North Coast Regional Water Quality Control Board

Subject: Notice of Violation and Investigative Order Pursuant to California Water Code Section 13267

File: Saggio Hills Development Project Site (a.k.a. Montage Healdsburg)
WDID No. 1B06169WNSO
WDID No. 1 49C375878

Figure 1. Receiving Water Sampling Locations

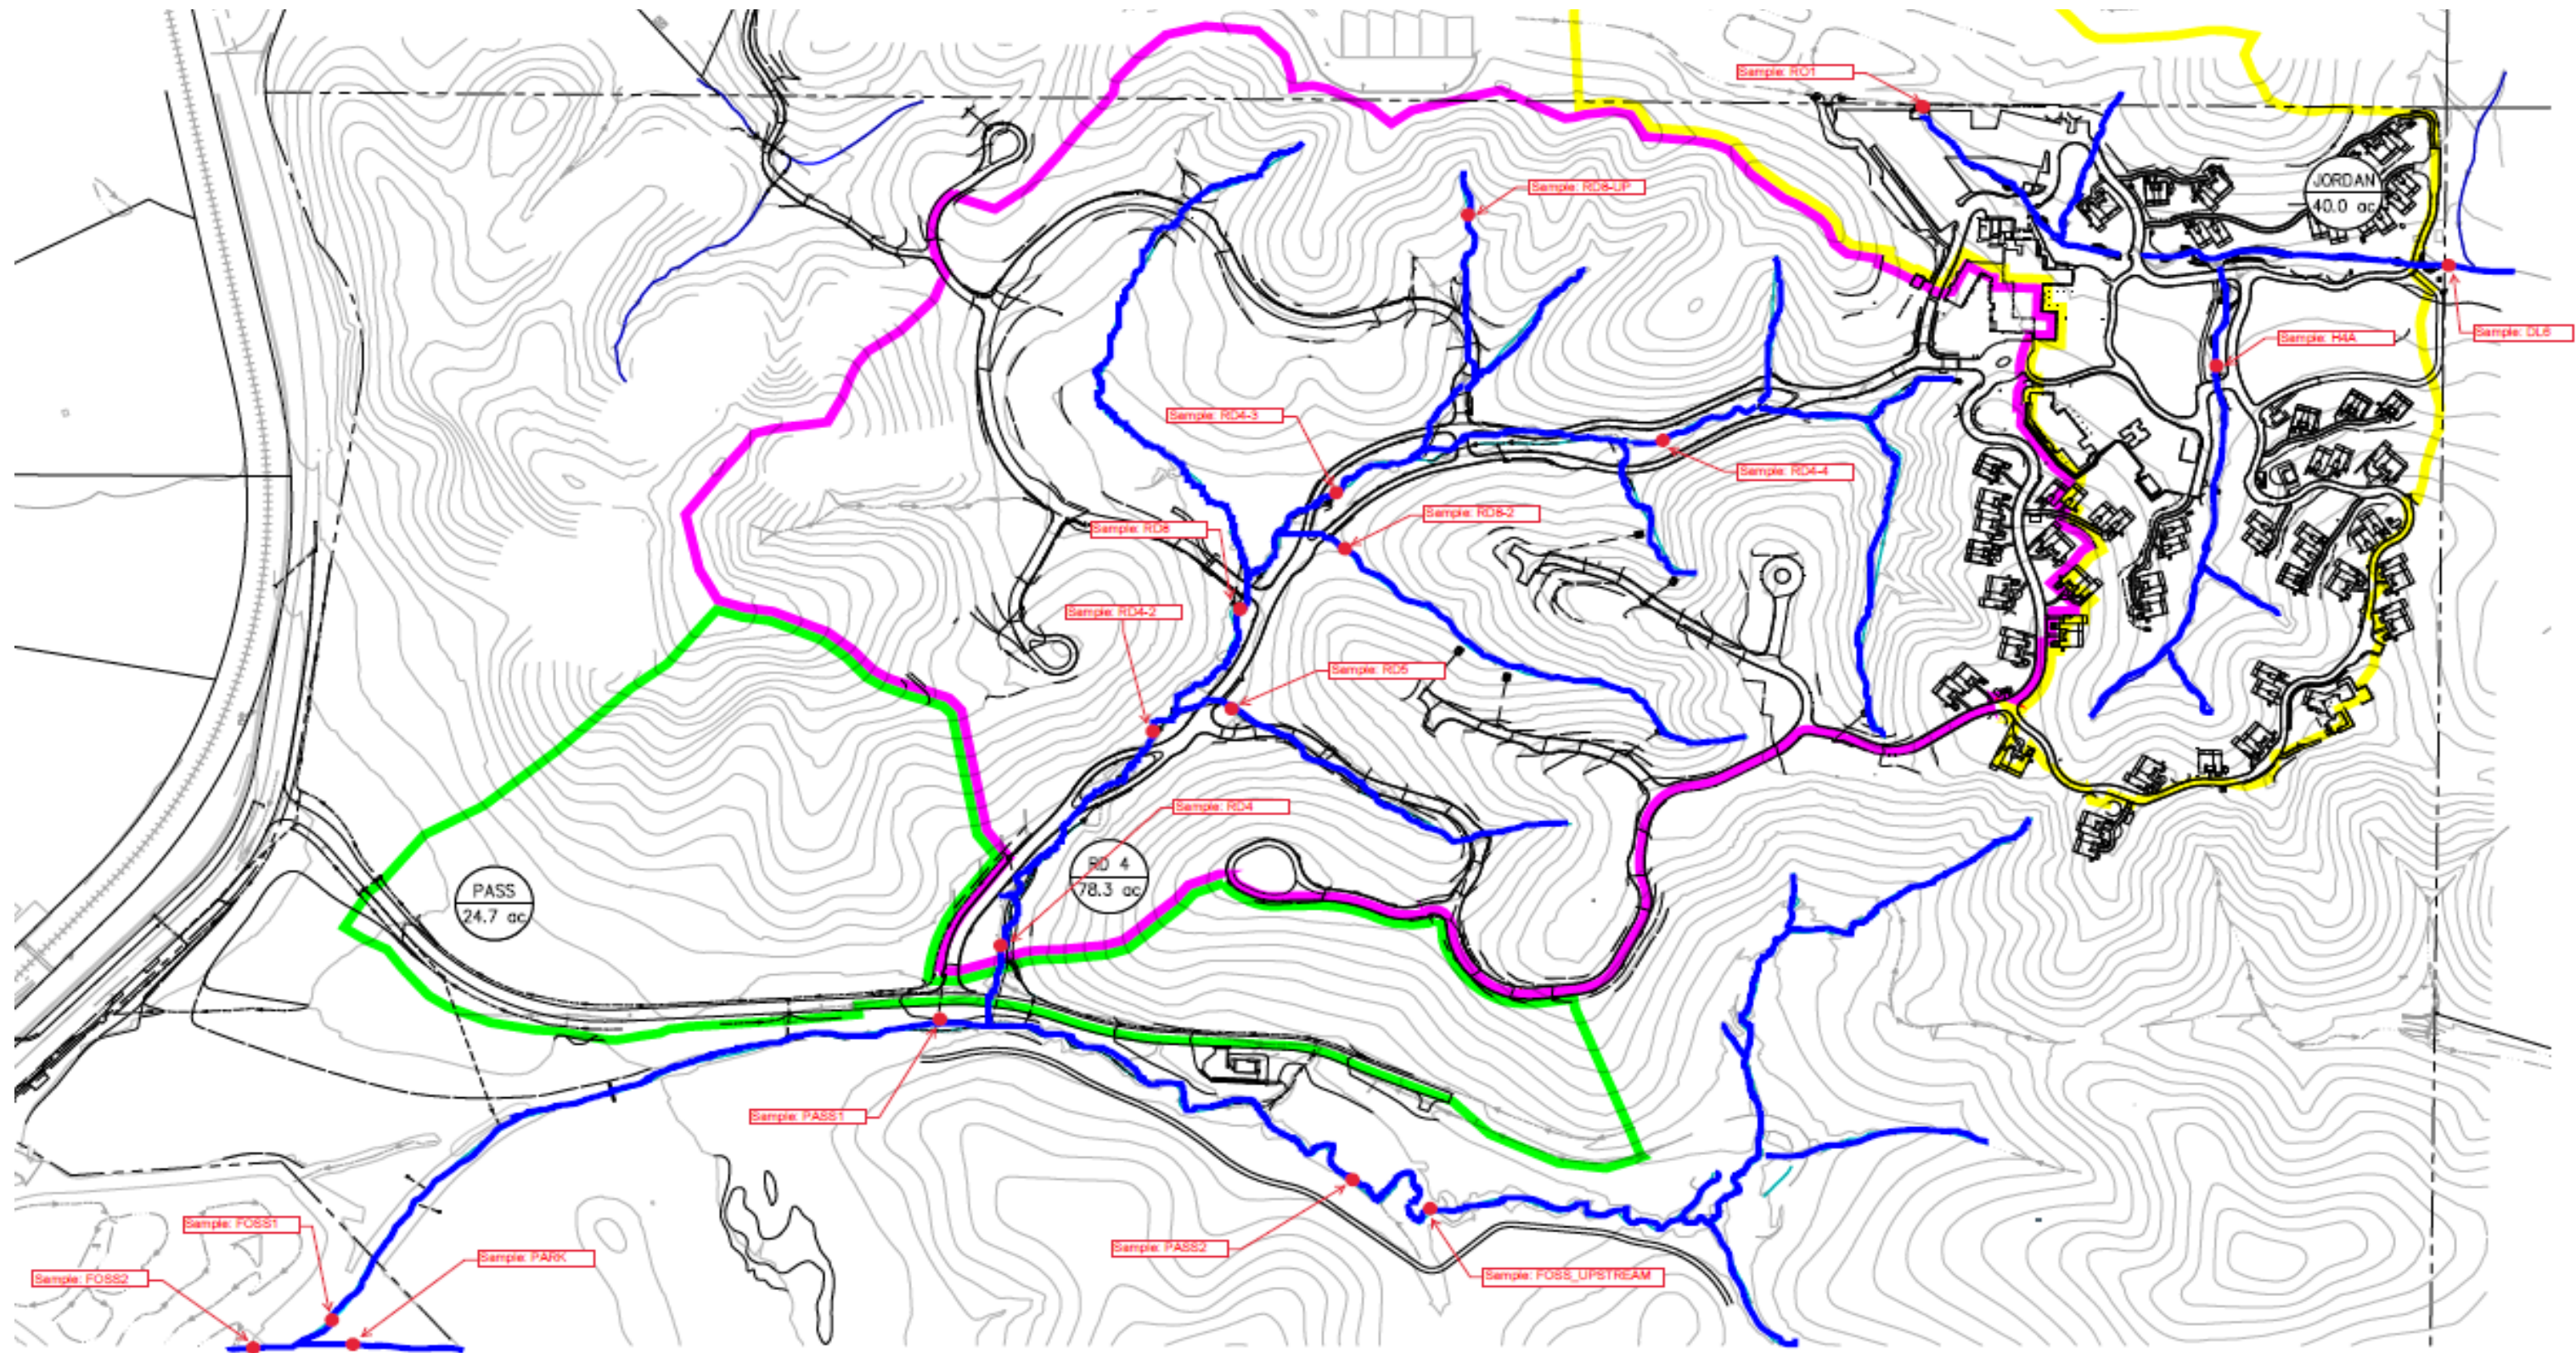
period with no precipitation. As shown in Figure 1, enclosed, and as described below, in-stream water quality samples shall be collected at the 17 specified locations throughout the Site. Unless otherwise noted, all samples shall be analyzed for suspended sediment concentration (SSC), total suspended solids (TSS), turbidity, and pH.

1. Foss Upstream – Background sample within Foss Creek, upstream of any input from construction Site storm water effluent.
2. Pass 2 – Within Foss Creek, upstream of the pumphouse. SSC and TSS are not required to be analyzed at this location.

3. Pass 1 – Within Foss Creek, downstream of the confluence with the unnamed tributary along Road 4.
4. Foss 1 – Within Foss Creek, prior to the confluence with the unnamed tributary from Parkland Farms.

5. Park – Within the unnamed tributary from Parkland Farms, upstream of the confluence with Foss Creek. SSC and TSS are not required to be analyzed at this location.

6. Foss 2 – Within Foss Creek, downstream of the confluence with the unnamed tributary from Parkland Farms.
7. RD4-4 – Within the unnamed tributary to Foss Creek along Road 4, upstream of the influence from Roads 5 and 8.

8. RD8-UP – Within the third order unnamed tributary to Foss Creek, upstream of influence of Road 8. SSC and TSS are not required to be analyzed at this location.

9. RD4-3 – Within the unnamed tributary to Foss Creek along Road 4, downstream from sample RD4-4.
10. RD8-2 – Within the third order unnamed tributary to Foss Creek, upstream of the crossing with Road 4.

11. RD8 – Within the unnamed tributary to Foss Creek, downstream of the southern Road 8 stream crossing. SSC and TSS are not required to be analyzed at this location.

12. RD5 – Within the third order unnamed tributary to Foss Creek, upstream of the Road 5 crossing with Road 4.
13. RD4-2 – Within the unnamed tributary to Foss Creek, downstream of the influence of Roads 5 and 8.

14. RD4 – Within the unnamed tributary to Foss Creek, downstream of the influence of Roads 5 and 8, and upstream of the stream crossing on Passalacqua Road.

15. R01 – Resort Area. Within the unnamed tributary to Jordan Pond, run-on from the neighboring landfill, and upstream of project influence.
16. H4A – Resort Area. Within the second order tributary to Jordan Pond, influenced by the hotel area.

17. DL6 – Resort Area. Within the unnamed tributary to Jordan Pond, downstream of the Site influence.
